SERVICE INFORMATION NO. SI 42-160

EASA Emergency Airworthiness Directive No. 2011-0152-E
TM TAE 125-0021, Rev 1 - Replacement Clutch
TM TAE 125-1011 P1, Rev 1 - Replacement Clutch
ATA-Code: 72-10

Technische Mitteilung Nr. / Datum: TM TAE 125-0021, Rev. 1 / 17.08.2011
Service Bulletin No. / Date TM TAE 125-0021, Rev. 1 / August 17, 2011

Technische Mitteilung TM TAE 125-1011 P1, Rev. 1 / 17.08.2011
Nr. / Datum:

Fig. 1 Shoulder on the rear gearbox cover

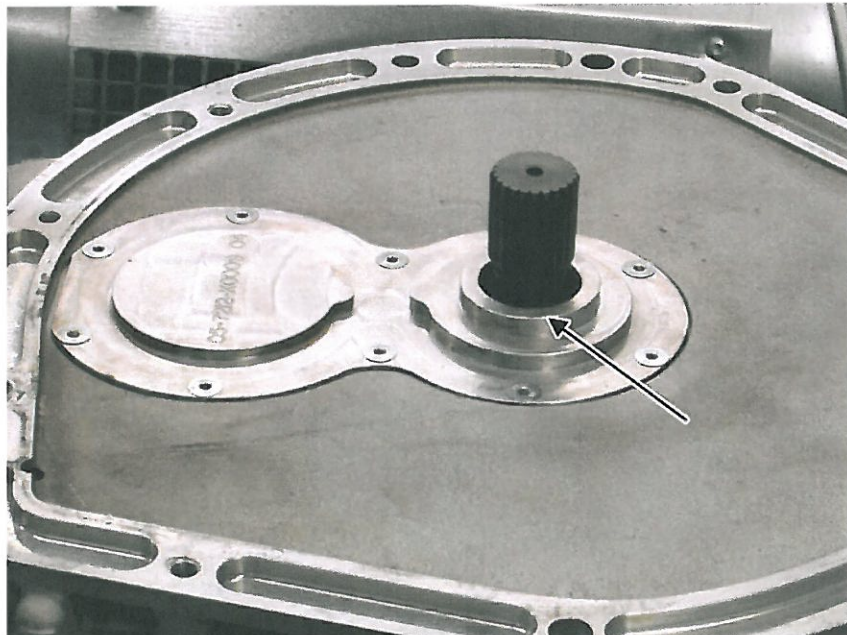
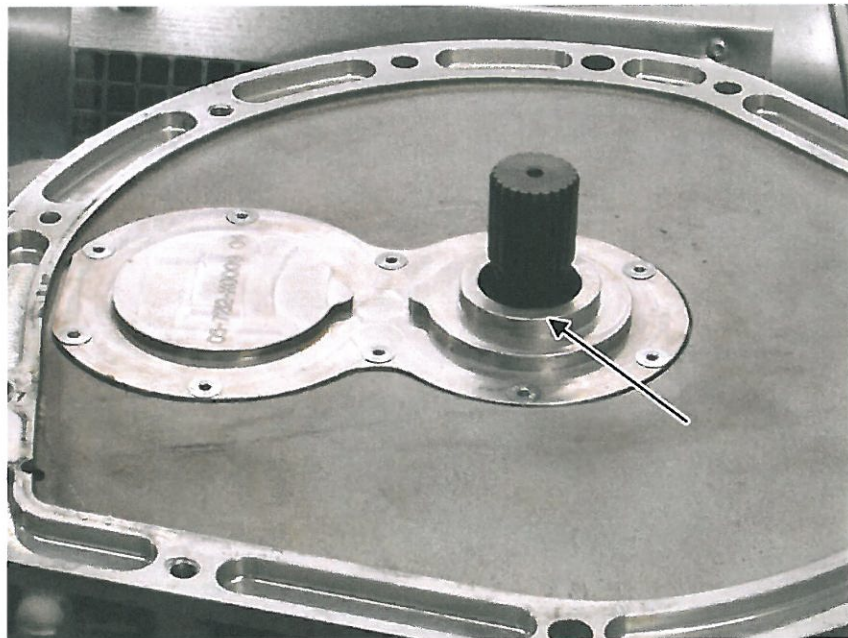
If the rear gearbox cover has the part number 05-7212-K000904 and the shoulder shown in Fig. 1, you must rework the rear gearbox cover in accordance to work steps which follow. Otherwise, proceed to step 19.

Fig. 2 Install special tool

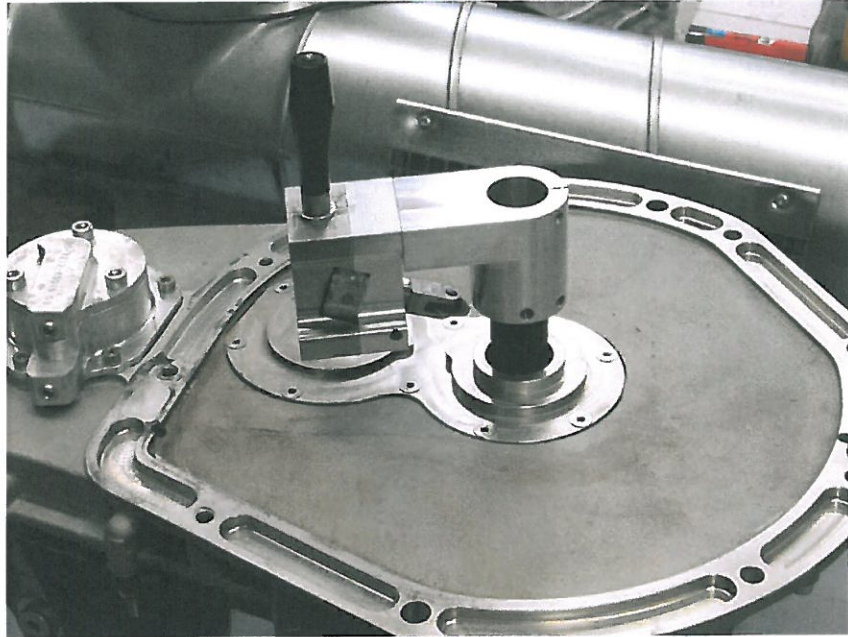
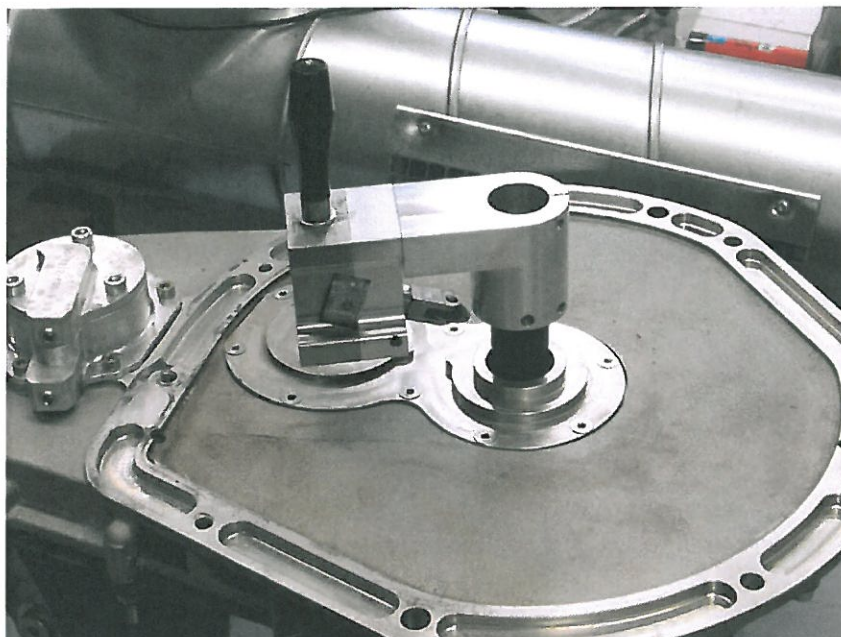
5. Put the special tool VR00388 to the input shaft of the gearbox. See Fig. 2.

◆ Note: Make sure that the two cylinder head screws at the special tool are loose. See Fig. 4.

Fig. 3 Adjust clearance with feeler gauge

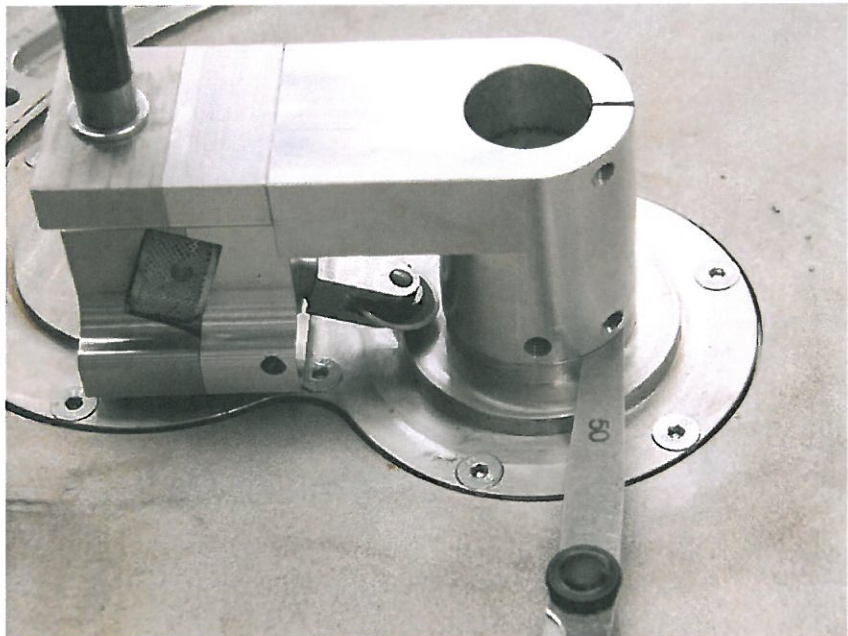
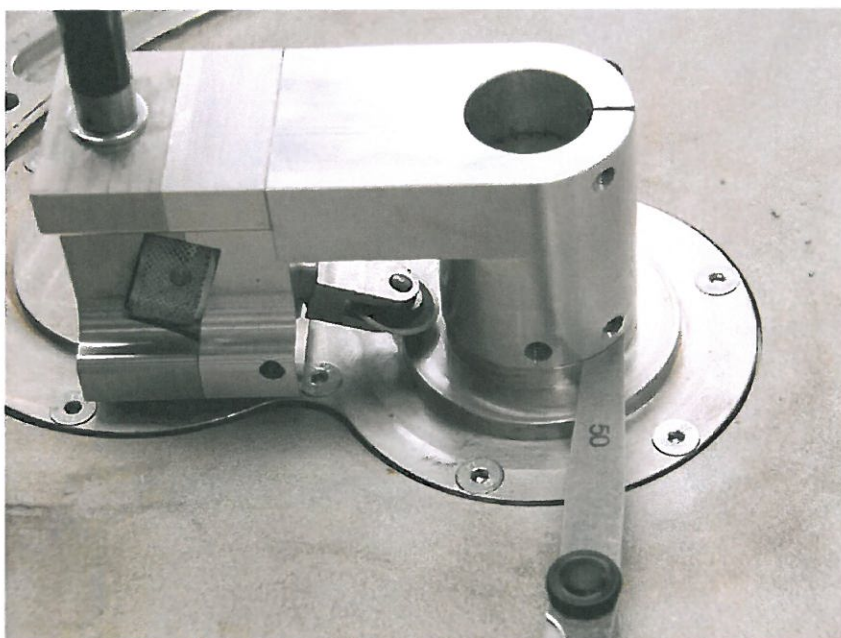
6. Move the special tool downwards to the rear gearbox cover until there is a clearance of 0.5mm between the special tool and the rear gearbox cover. Use a feeler gauge to ensure the clearance of 0.5mm. See Fig. 3.

Fig. 4 Screws for the attachment of the special tool

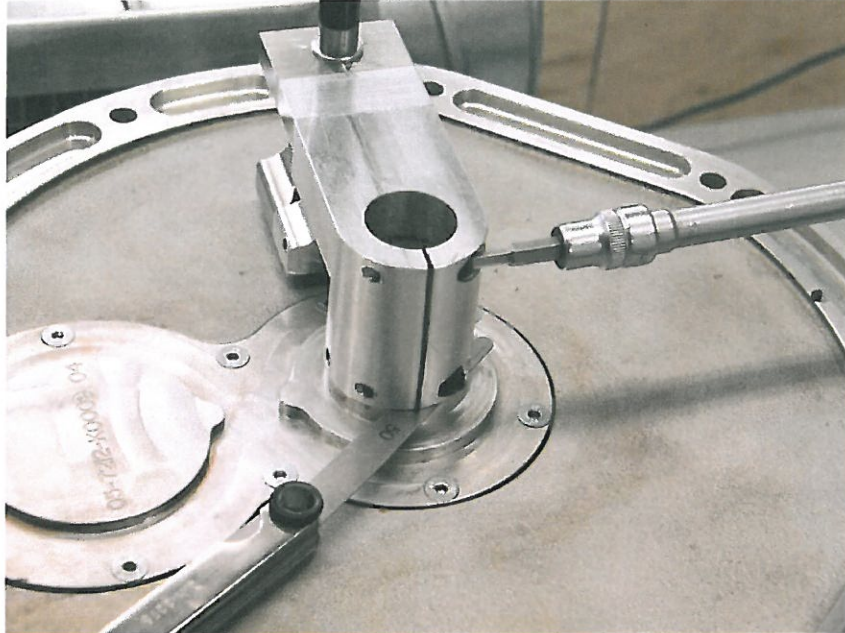
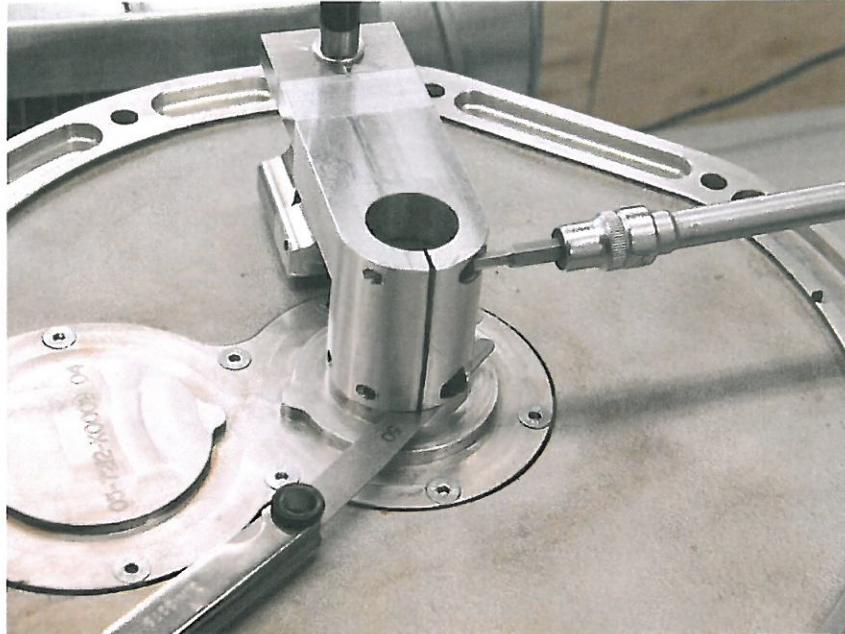
7. Tighten the two cylinder head screws to the specified tightening torque. See Fig. 4.

Tightening Torque:

20 Nm

Fig. 5 Turn the adjustment wheel to feed the cutting tool

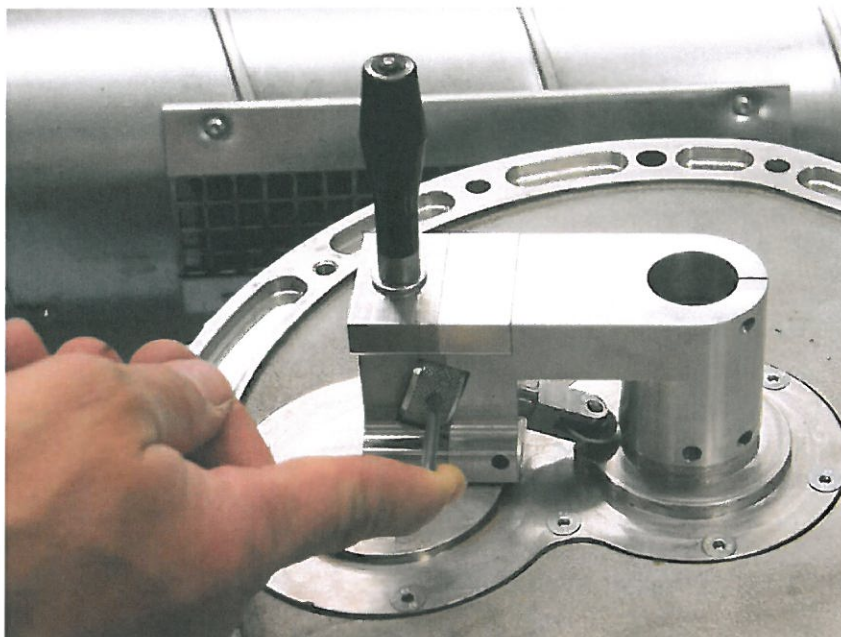
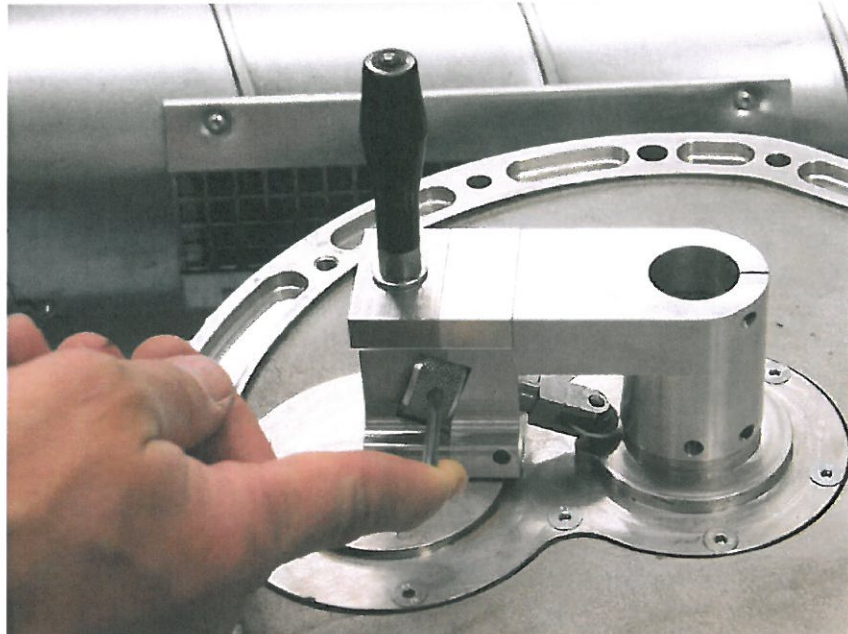
8. Remove the feeler gauge.
9. Turn the adjustment wheel until the cutting tool touches the shoulder of the rear gearbox cover.
10. Put the cylinder pin in the drill hole of the adjustment wheel. See Fig. 5.
11. Turn the adjustment wheel until the cylinder pin touches the housing of the tool. See Fig. 5.

■ **CAUTION:** Do not turn the adjustment wheel more than 45°. It can cause damage to the cutting tool!

◆ **Note:** Use the cylinder pin to turn the adjustment wheel. See Fig. 5.

Fig. 6 Turn the special tool

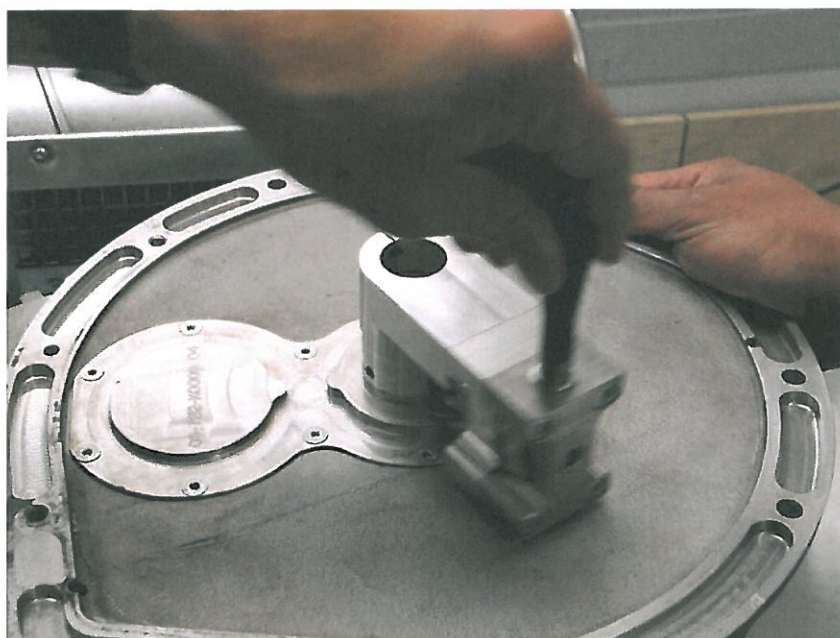
12. Turn the special tool together with the gearbox input shaft a few revolutions. Use the handle bar. See Fig. 6.

Fig. 7 Shoulder is cut through

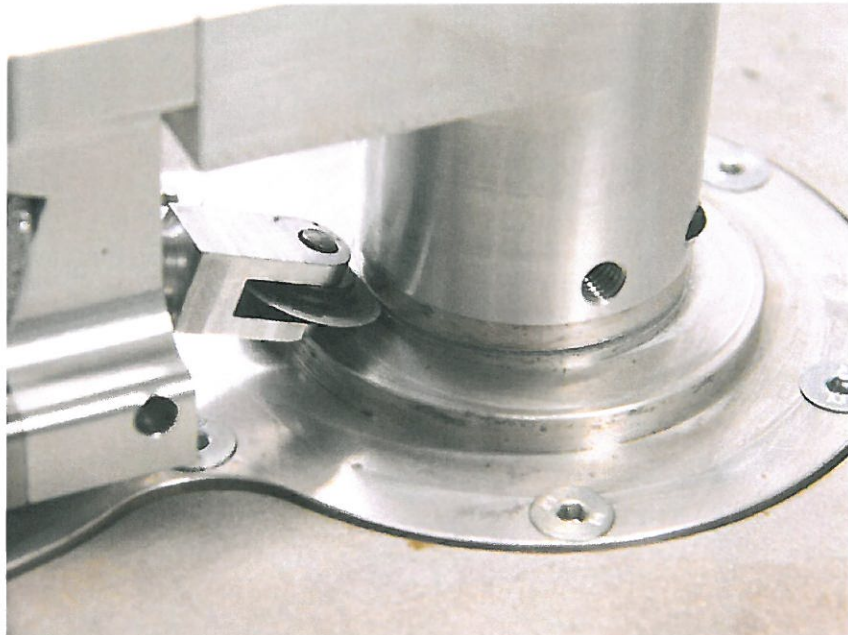
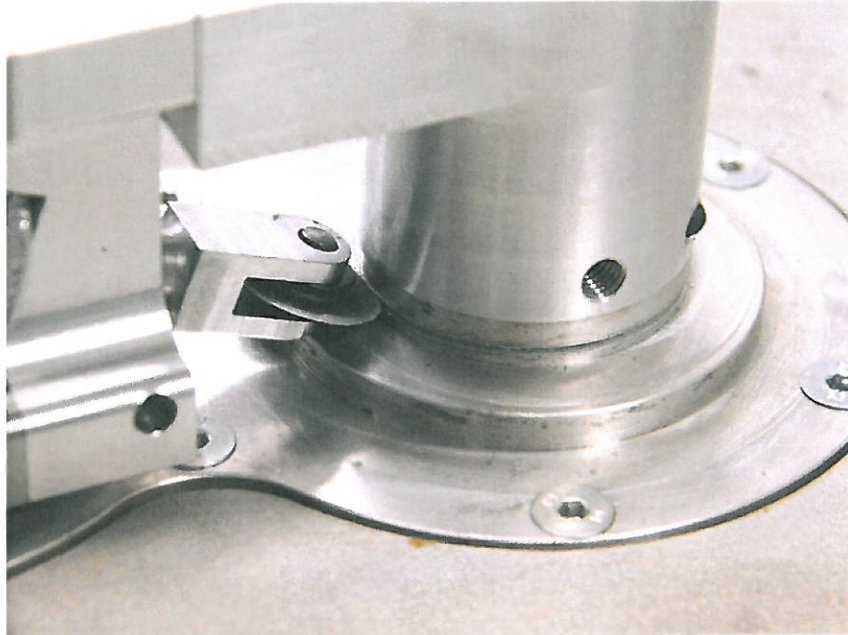
13. Feed the cutting tool. Refer to work step 12. Then turn the special tool. Refer to work step 13. Repeat work step 12 and 13 until the shoulder of the rear gearbox cover gets loose. See Fig. 7.

Fig. 8 Remove the shoulder

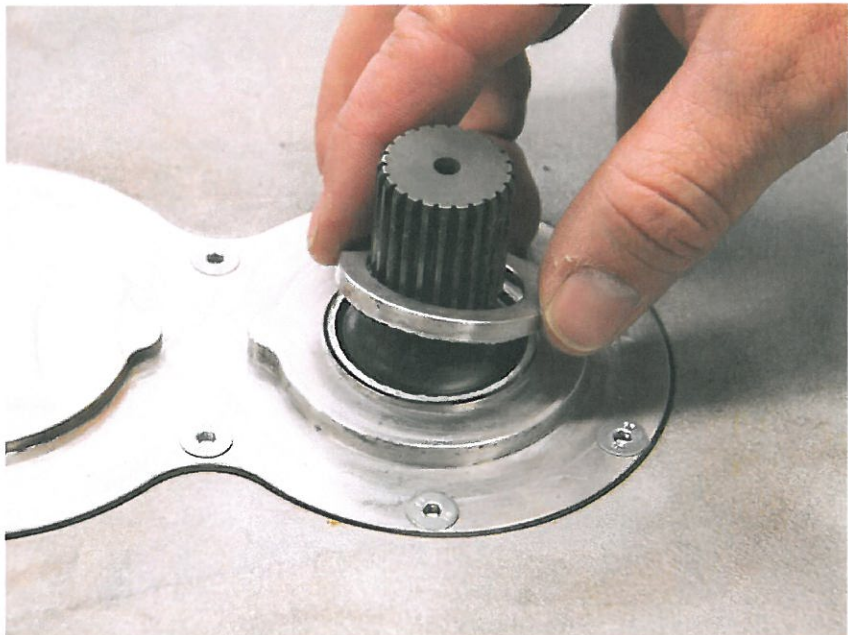
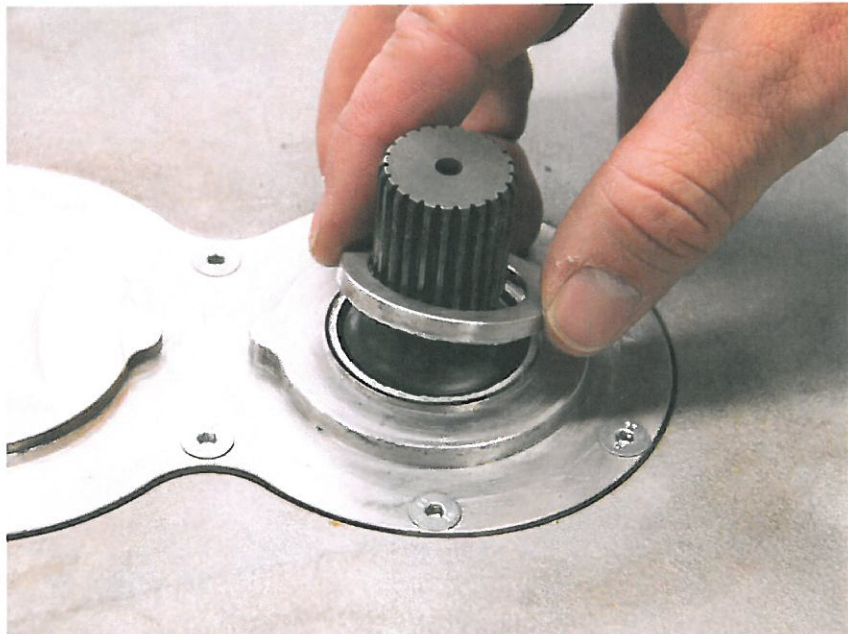
14. Turn the adjustment wheel backwards until the cutting tool has enough clearance to the shoulder to remove the special tool.
15. Loosen the cylinder head screws of the special tool.
16. Remove the special tool.
17. Remove the shoulder of the rear gearbox cover. See Fig. 8.
